**2006 IRC
Recommended Action for IRC Section R602.10.5
Continuous Structural Panel Sheathing (Wall Bracing)**

Texas Jurisdictions Adopting the 2006 IRC

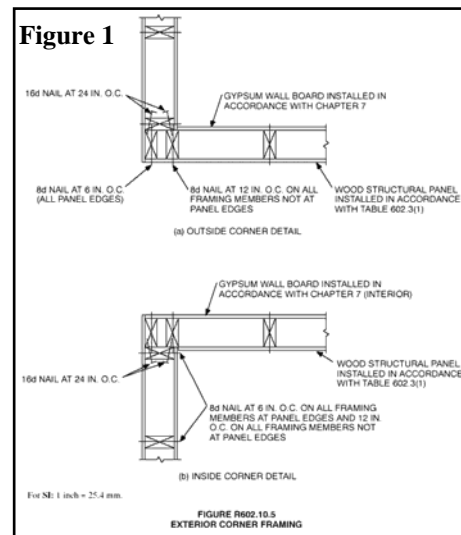
A more appropriate solution to the above concern would have been to clarify that the corner detail in Figure R602.10.5 (see Figure 1 above) requires a minimum 2-foot corner return panel at the ends of a continuously sheathed braced wall line. This would appropriately allow a transition to other bracing methods on other wall lines while also properly adhering to the research data that supports the continuous sheathed bracing method first introduced in the 2000 IRC.
